RTS-TB-016**1-May -2013****KP-32 Sector Protection / No Firmware Upgrades Possible**

RTS™ TECHNICAL BULLETIN

3.0 Detailed Rework Instructions

7) Locate U2 and U3 on the main PCBA (F.01U.249.831)

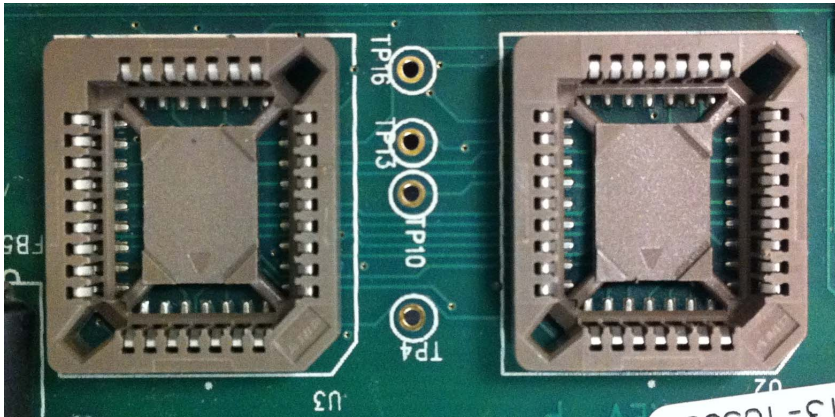
In early 2013, Bosch moved manufacturing of the Main PCBA used in the construction of KP-32 product variants from a North American facility to an Asian Bosch facility. In the process, sectors of the Flash memory device used on the boards were accidentally protected at the factory. Protecting or securing sectors of a Flash memory prevents them from being over-written accidentally. It is usually done for critical information that must be protected under all circumstances (critical device information and licensing, boot recovery code, etc.). In this case, the improper protection of the Flash memory prevents the field upgrade of firmware for the KP-32 for customers. Customers who have been shipped KP-32 units with these protected devices will not be able to upgrade them for any firmware feature changes nor will they be able to upgrade these units to support the OMNEO OKI devices.

8) Carefully remove U2 and U3 ICs from their respective sockets with K293-ND or similar tool and put aside

9) Carefully Insert F.01U.110.903 into U2 socket

10) Carefully insert F.01U.110.904 into U4 socket
